NOTICE OF PUBLIC MEETING CITY OF MILLERSBURG PLANNING COMMISSION Tuesday September 18, 2018 6:00 p.m.

Proposal: The applicant is proposing to add a 70 x 168 pole-barn style building, about 30 feet high, for the storing of plywood. No habitable space is proposed within the structure.

SUBJECT: PA 18-04 Plywood Solutions - Engineering Comments

TO: Matt Straite, City Planner
FROM: Lora Ratcliff, Senior Deputy Fire Marshal
DATE: September 6, 2018
SUBJECT: 6523 Old Salem Rd, Millersburg – New 11,760 Sq Ft Plywood Storage Building– Albany Fire Department Comments

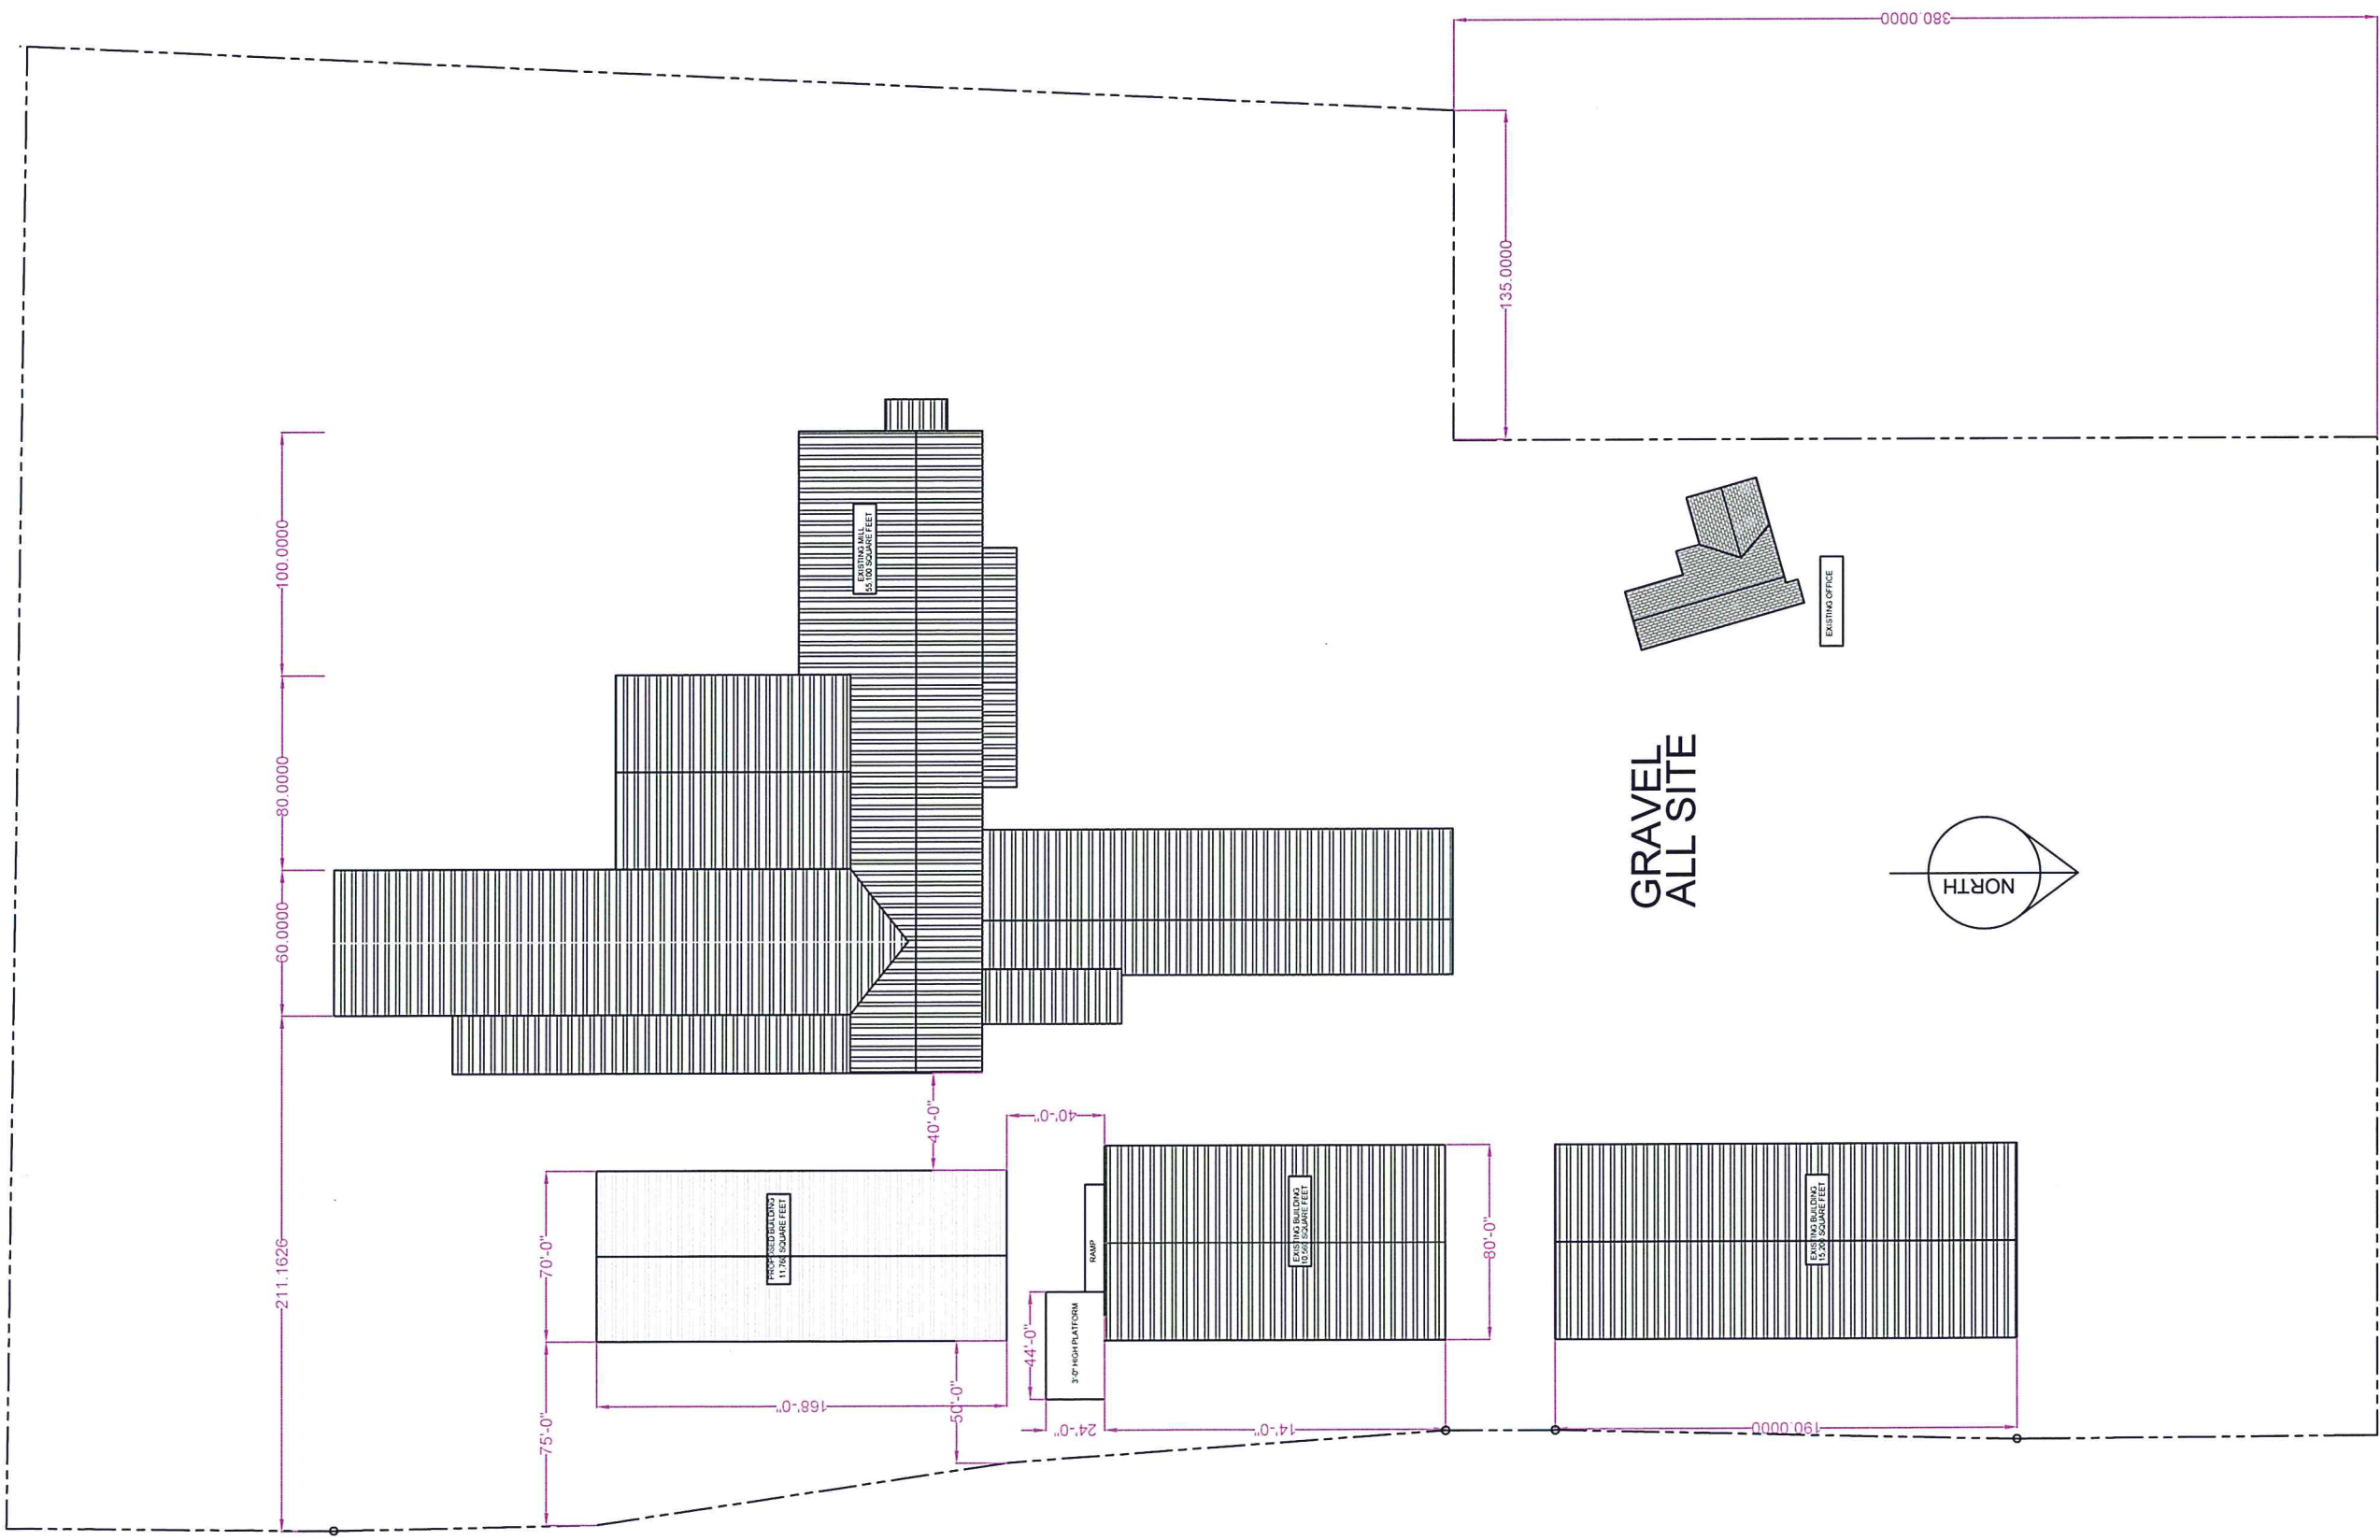
ANALYSIS: Crooks Creek is located on the southern portion of the property. The structure is proposed on the southern portion of the development, about 250 feet from the southern boundary, or about 150 feet from Crooks Creek. Section 5.118 requires a 15-foot setback from non-fish bearing streams. The proposed structure is outside this setback as shown on the site plan.

① NORTH ELEVATION

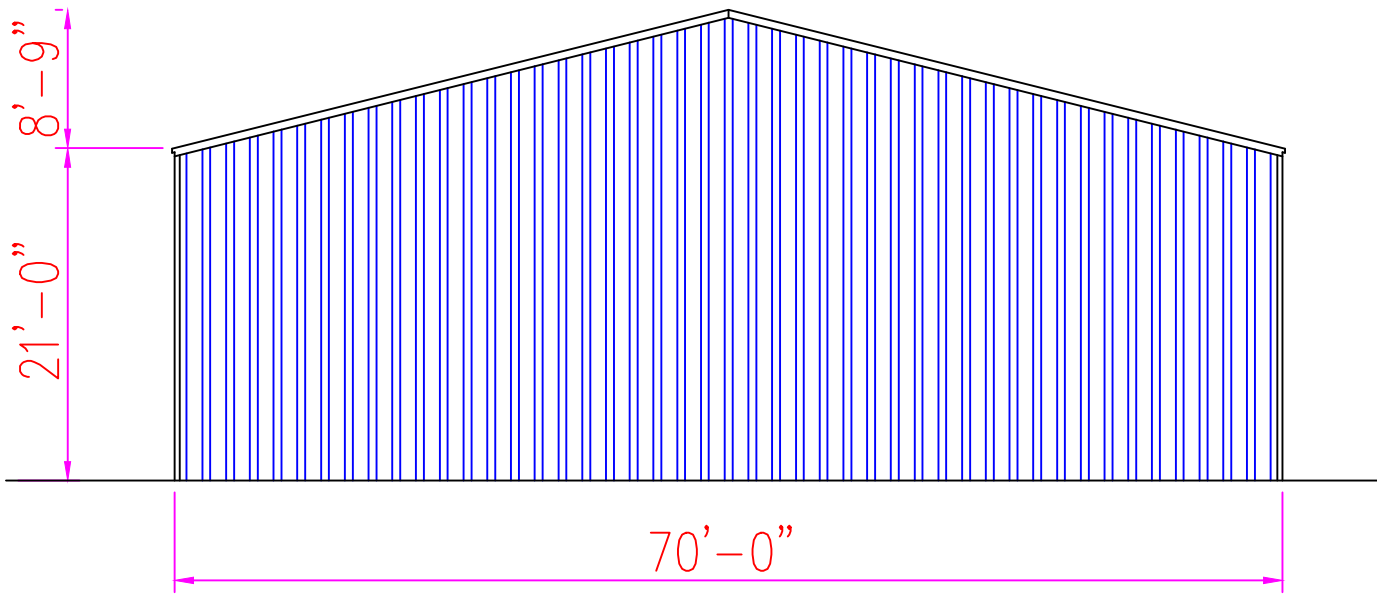
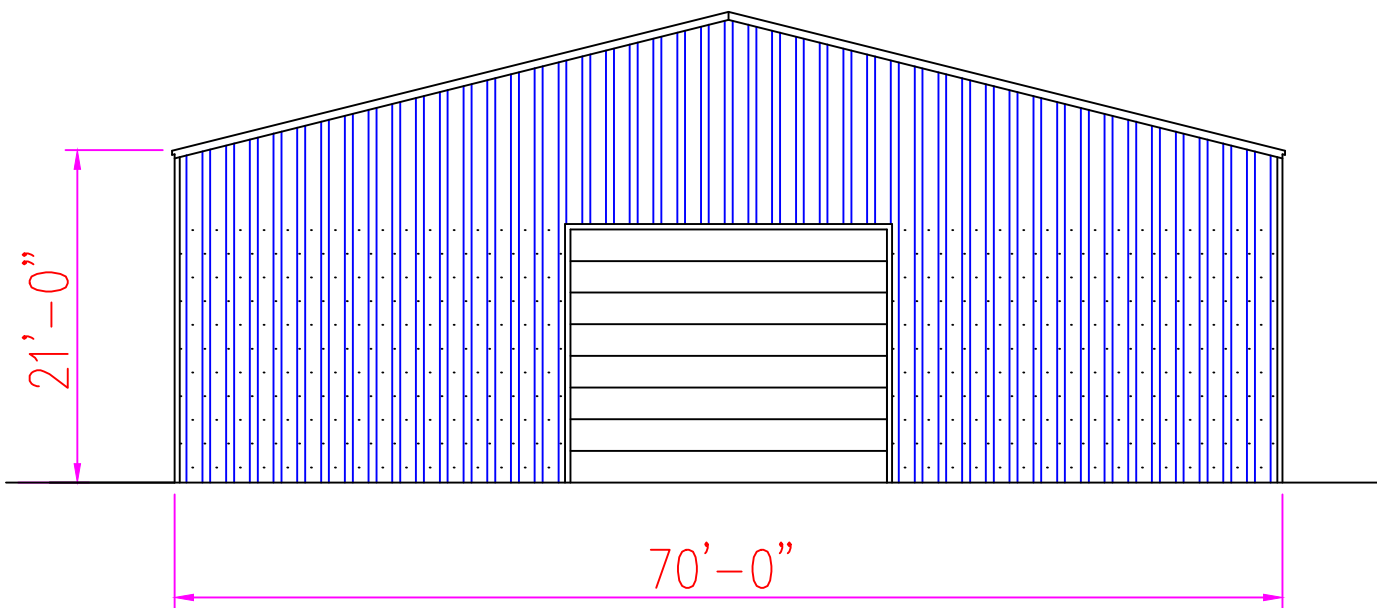
The proposal does not meet this criterion. The nearest hydrant is on Old Salem, approximately 1,800 feet from the proposed structure.

Prior to final inspection of the structure, the applicant shall provide the City with a clearance letter (or email) from the Albany Fire Department indicating that all comments in the September 6, 2018 letter are addressed to the satisfaction of the Fire Department.
